EDGEWATER REDEVELOPMENT

SUBMITTAL PACKAGE
URBAN DESIGN COMMISSION

JANUARY 13, 2010

DESIGN EVOLUTION – INTEGRATION OF UDC COMMENTS

CONFIGURATION OF STAIR

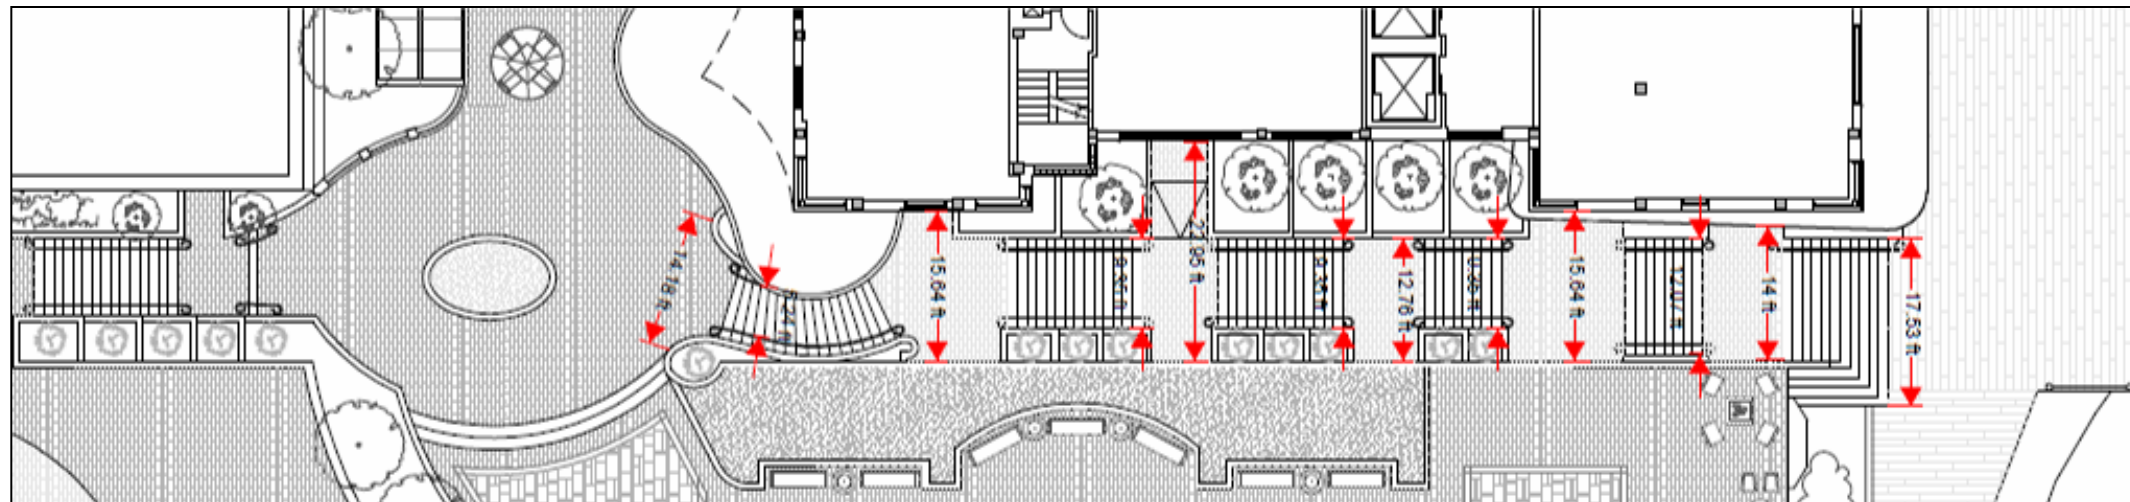
INFORMATION REQUEST – Provide details on the width of the stair, including specific design details.

UDC requested that we study alternate option for stair. An alternate proposal is included above, it responds to UDC comments including:

State Capitol Stair is Approximately 17'-7"

- Stair is integrated with entry features, especially at top canopy;
- Stair treads are widened in certain areas and alternate with planters;
- Stair width is compared against other stairs.

REDUCE BUILDING HEIGHT AND MASS

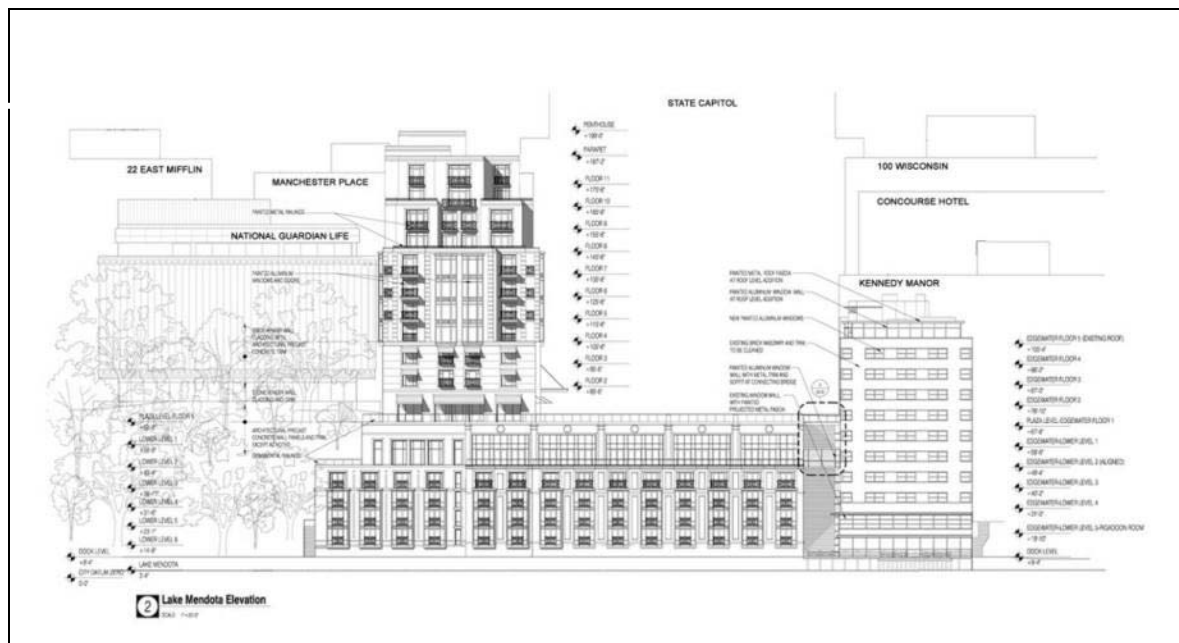
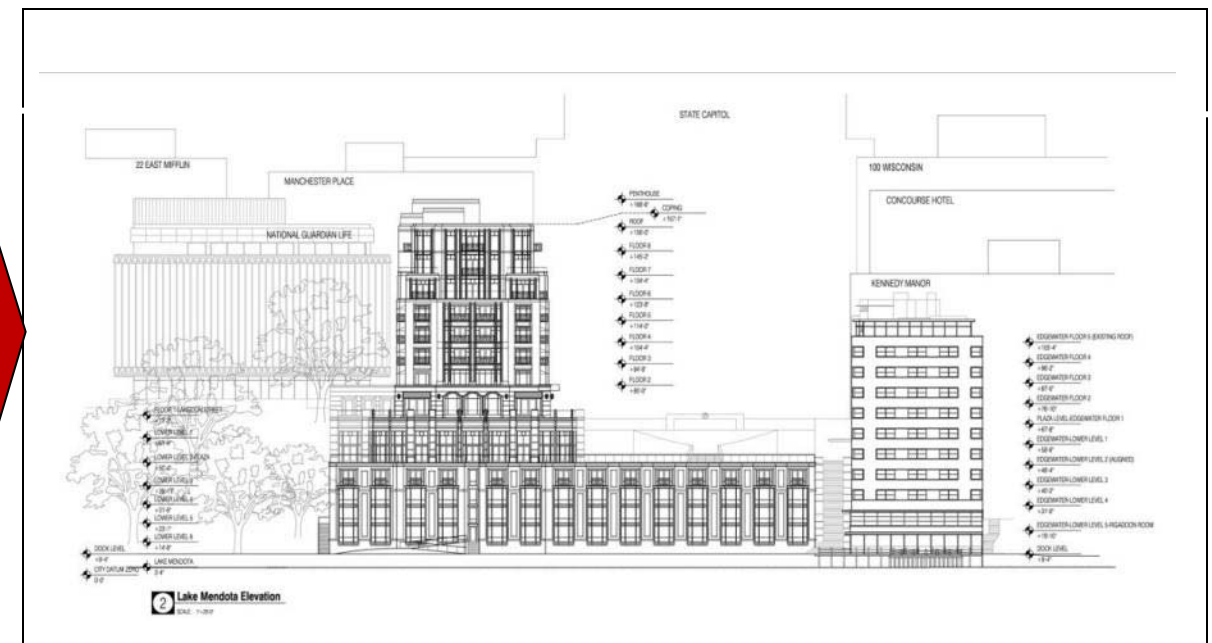
Information Request: Explain how the developer has responded to requests by UDC and others to reduce height and mass off the building.

REDUCED HEIGHT BY 3 FLOORS / 30 FEET

- » Reduced Height of Tower by 3 Stories, 30 FT;
- » Reduced the Floor-to-Floor Height on Tower;
- » Removed 2 Stories, 20 FT of Structure in ROW;
- » Reduced Total Program by 93,000 SF;
- » Reduced the Size of the Penthouse;
- » Removed the need for a Conditional Use Permit for the Penthouse Penetration of Capitol Height;
- » Better Related Building to Surrounding Context (e.g. NGL / Kennedy Manor)

CALCULATION OF FLOOR AREA RATIO

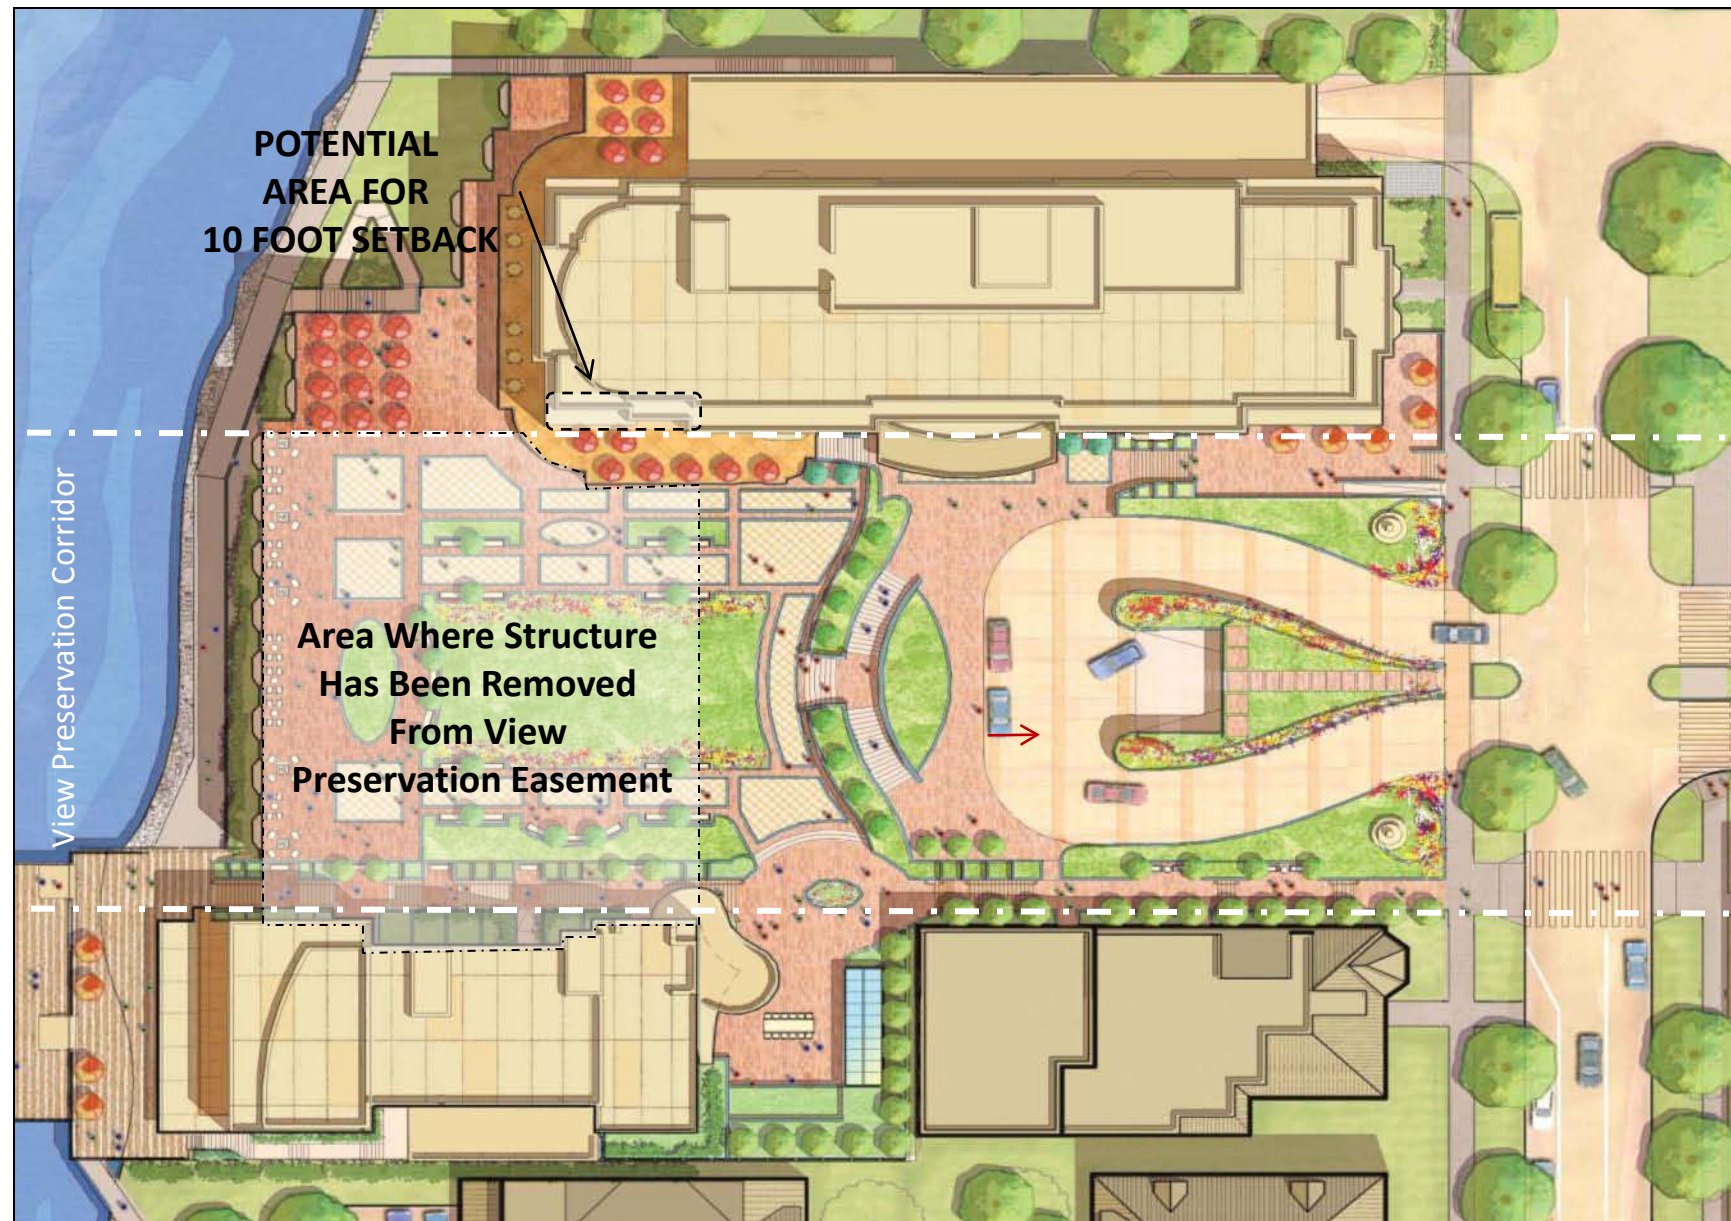
INFORMATION REQUEST: Provide specifics about how the FAR was calculated, clearly identifying the portions of the building and the site that were included. How does this compare to other buildings in the neighborhood and downtown?

The Project Floor Area ratio (FAR) was calculated by taking the total gross area of the building less the below grade parking area to get an estimate for the total occupied gross building area of 249,529 SF.

The Project Area includes all land included as part of the Project, including that land which is made part of the public plaza in the Wisconsin Avenue right-of-way. The FAR based on the Total Project Area is estimated at 2.81.

The Site Area includes only the private land that is made part of the Project (exclusive of that portion of the Project that is located in the Wisconsin Avenue right-of-way). The FAR based on the Site Area is 3.44.

BUILDING SETBACK

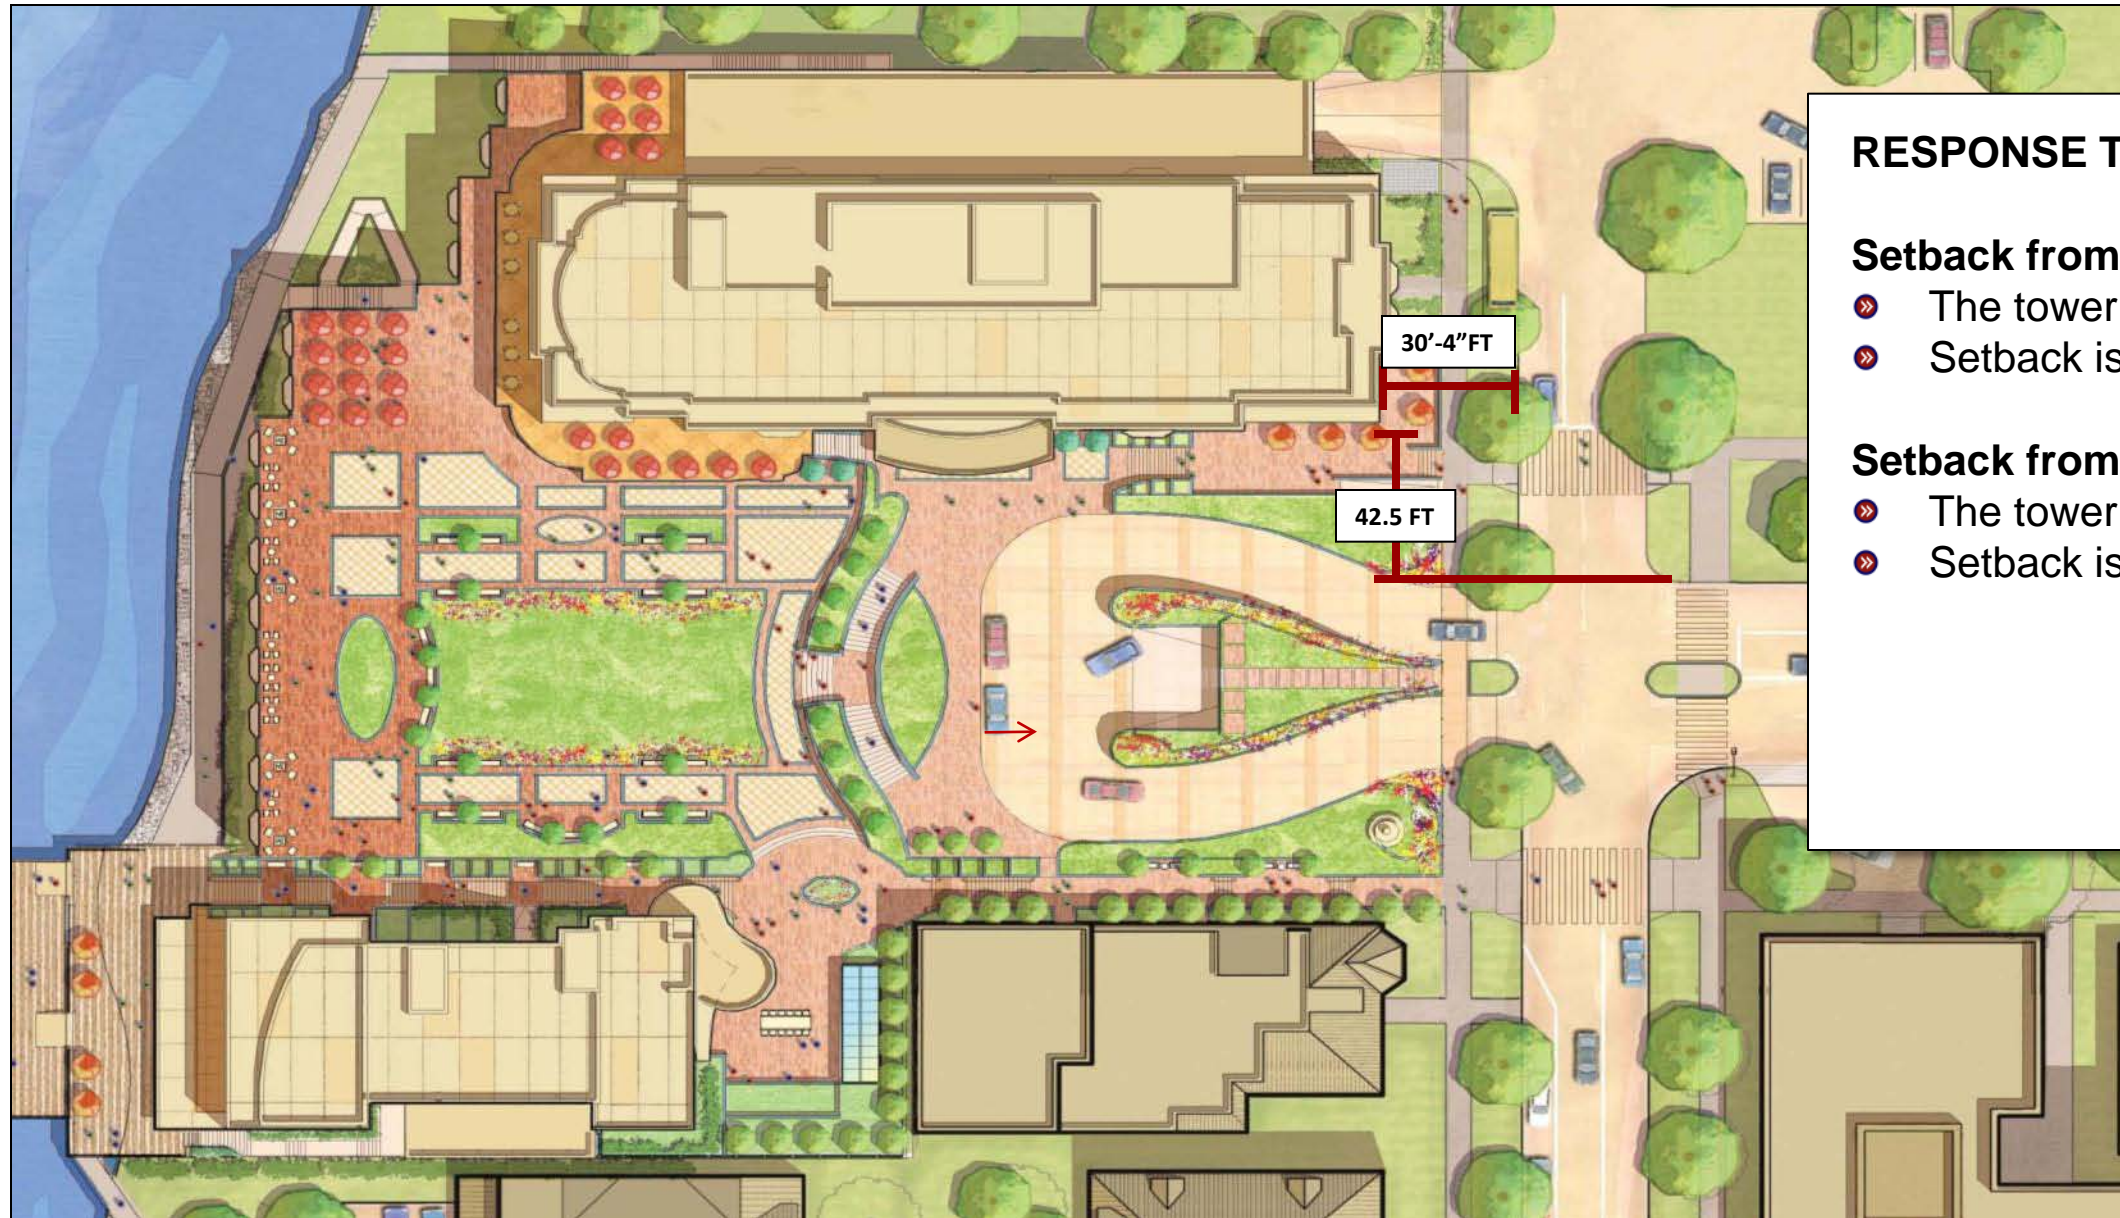
INFORMATION REQUEST: Explain the building setback in relation to the view preservation easement and 1965 Ordinance.

- The buildings are organized around a 132 FT wide view preservation corridor;
- The setback from the view preservation corridor is consistent with build-to line of 2 Langdon and Edgewater;
- The Ordinance that established in the 1970's street vacation required a 10 foot setback for any building built above the existing premises. The area impacted by this setback is highlighted in the adjacent plan.

The adjacent plan highlights the area where structure is removed from the 1970's building as compared to the area where the 10 FT easement may be applied to the building. The impact of removing the 1970's building far outweighs the impact of a 10 FT setback and this attention will greatly enhance the existing conditions and exceed the intent of the language of the Ordinance..
